Access Compliance Report

Public Rights-of-Way

(Curb Ramps)

Intersection ID: 29981	Main Street: OLD_CAROLINA_DR	Cross Street: WINDING_RIVER_DR	Location: E
ADA ID: 5B7879EF8303	Ramp Type: PerpDiag	Initial Pass/Fail: Fail	Overall Compliance: No
Severity Score: 33.75			
Codes/Mitigation Info/Possible Solution		Field Measurements/Component Compliance

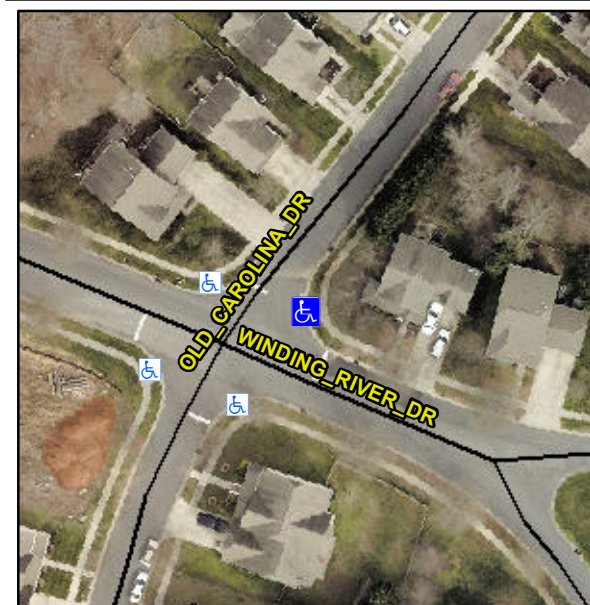
Not Found, R304.5.1, R304.5.3

Compliance	Description	Data	Compliance	Description	Data
N/A	Ramp Length (in)	72.0	Yes	Ramp Slope (%)	6.5
No	Ramp Width (in)	47.5	No	Ramp XSlope (%)	8.2
N/A	Flare Type LT	N/A	N/A	Flare Type RT	N/A
N/A	Flare Slope LT (%)	N/A	N/A	Flare Slope RT (%)	N/A
N/A	Flare Traversable LT?	N/A	N/A	Flare Traversable RT?	N/A
N/A	Landing Length (in)	N/A	N/A	DWS Provided?	N/A
N/A	Landing Width (in)	N/A	N/A	DWS Contrast?	N/A
N/A	Landing Slope (%)	N/A	N/A	DWS Length (in)	N/A
N/A	Landing X Slope (%)	N/A	N/A	DWS Full Width?	N/A
N/A	Landing Curb? (Y/N)	N/A	N/A	DWS Offset (in)	N/A
N/A	Shared Landing?	N/A			
N/A	Gutter Ponding?	N/A	N/A	Gutter Slope (%)	N/A
N/A	Gutter Lip Ht (in)	N/A	N/A	Gutter X Slope (%)	N/A
N/A	Painted X Walk1?	No	N/A	Painted X Walk2?	No
	X Walk 1 Direction	To NW		X Walk 2 Direction	To SW
N/A	X Walk 1 Width (in)	N/A	N/A	X Walk 2 Width (in)	N/A
	X Walk 1 Slope (%)	8.0		X Walk 2 Slope (%)	2.1
	X Walk 1 X Slope (%)	2.0		X Walk 2 X Slope (%)	8.4

N/A	Ramp inside XWalk1?	N/A	N/A	Ramp inside XWalk2?	N/A
	Road Slope (%)	7.6	N/A	Clear Space?	N/A
	Road X Slope (%)	4.5	N/A	Clear Space to XWalk (in)	N/A
N/A	Any Obstructions?	N/A	N/A	Storm Grate/Utility Hazard?	N/A
	Obstruction Type			Storm Grate/Utility Type	
		N/A			N/A
			Yes	Surface Condition? (G/P)	Good

Remove & Replace Curb Ramp With Two New Directional Ramps or Equivalent.
